UNITED STATES PATENT AND TRADEMARK OFFICE

APPLICATION NO.	FILING DATE	FIRST NAMED INVENTOR	ATTORNEY DOCKET NO.	CONFIRMATION NO.
10/784,763	02/23/2004	Jayesh Jasapara	3-7	2221

Office Action Summary

DETAILED ACTION

FIG. 6

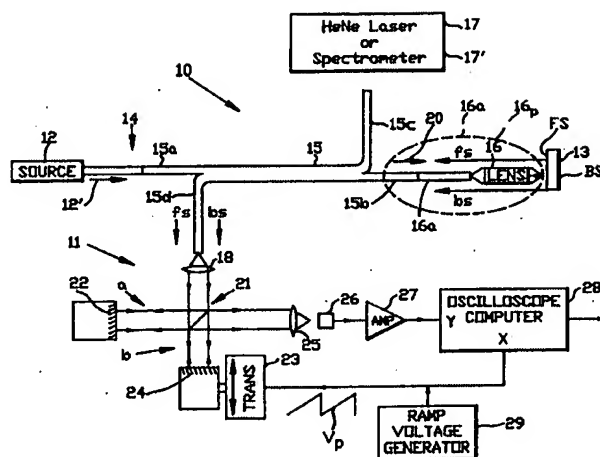
With regard to claim 1, McLandrich et al teach an optical coherence tomography arrangement(Fig. 6) for measuring predetermined characteristics of an optically transparent object, the arrangement consisting of;

a broadband lightwave source(Fig. 6, 12) for generating a broadband optical test signal;

an optical beam splitter including a pair of input arms and pair of output arms(Fig. 6, 15),

a first input arm coupled to the output of the broadband lightwave source(Fig. 6, 15a) for supporting the propagation of the broadband optical test signal through the optical beam splitter,

a lensing arrangement(Fig. 6, 16) coupled to a first output arm of the optical beam splitter(Fig. 6, 15b), the lensing arrangement for first collimating and then focusing the broadband optical test signal(column 8, lines 19-20) toward an optically transparent object to be measured(Fig. 6, 13); and

an optical spectrometer(Fig. 6, 11,28), coupled to a second input arm of the beam splitter(Fig. 6, 15d); said optical spectrometer receptive a plurality of interfering reflected signals from the optically transparent object disposed beyond the lensing arrangement,

the optical spectrometer for providing a spectrogram signal of the plurality of interfering reflected signals and generating a fast Fourier transform of the spectrogram signal associated with the optical path length of the measured object,

wherein signal peaks within the fast Fourier transform are related to transition interfaces between materials in the optically transparent object and are associated with the predetermined characteristics of the optically transparent object.

With regard to claims 1 and 2, the remaining claim limitations found are functional limitations and these limitations can be met by the prior art if the structure of the prior art is capable of performing the claimed functions. Clearly the interference spectrometer 11 and the computer 28 are capable of performing Fourier transform analysis, also see column 6, lines 61-64. For functional language to limit an apparatus claim the limitation must be claimed using a "means-plus-function" format of 35 U.S.C. § 112, sixth paragraph.

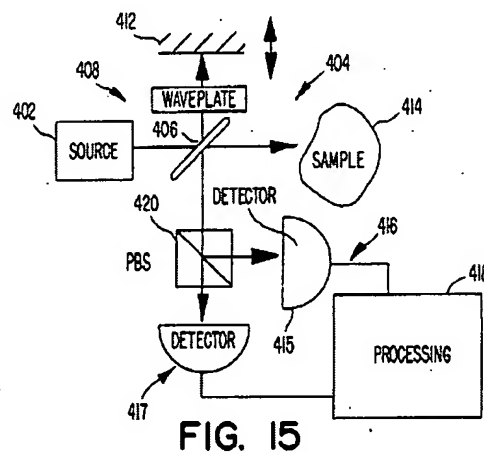
McLandrich et al fail to teach a first collimating lens and a second focusing lens, instead teaching a graded index (GRIN) rod lens 16 to collimate and optionally focus the measurement beam onto the sample 13 (column 8, lines 15-19). The GRIN lens is not specifically coupled directly to the fiber.

Official notice is taken that various telescopic lens arrangements, including the claimed collimating lens coupled to a focusing lens, are notoriously well known optical sample illumination optics. Further, coupling a GRIN lens directly to an optical fiber sensor tip is a well known configuration. See In re Malcom, 1942 C.D. 589; 543 O.G. 440.

With regard to claim 5, it would have been obvious to one of ordinary skill in the art at the time the invention was made to modify McLandrich by replacing the GRIN lens with an equivalent bulk optical lens arrangement.

The motivation for this modification would have been based on availability of the various equivalent optical elements and the distance between the fiber and the sample.

With regard to claims 6-8, it would have been obvious to one of ordinary skill in the art at the time the invention was made to modify McLandrich by connecting the GRIN lens directly to the fiber tip of the fiber end.

The motivation for this modification would have been based on the desire to form an integrated sensor head, further it has been held that forming in one piece an article which has formerly been formed in two pieces and put together involves only routine skill in the art, *Howard v. Detroit Stove Works*, 150 U.S. 164 (1893).
